PGAAMCC.

ADDENDUM #1 7/05/11

Slide-Swingwide Door instead of Double Door

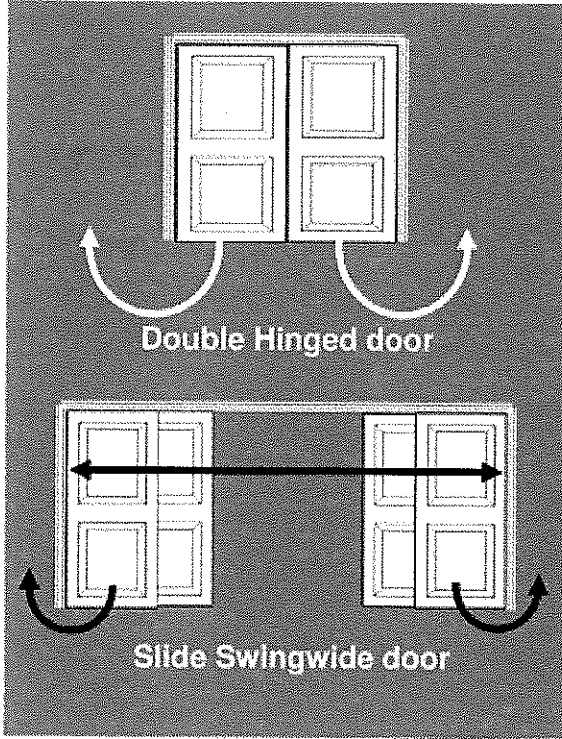
Replace the proposed new door identified as DI-14 in the bid documents with the new Slide Swingwide Door specified and attached herein.

Instead of the 64" opening for the scheduled door at this location (DI-14) use 124" opening to provide and install a Slide Swingwide door 12' opening. Manufacturer's standard hardware shall be provided, comparable to the hardware functions previously specified.

The door style shall be from the manufacturers solid door series 3300. www.inventiveusa.com
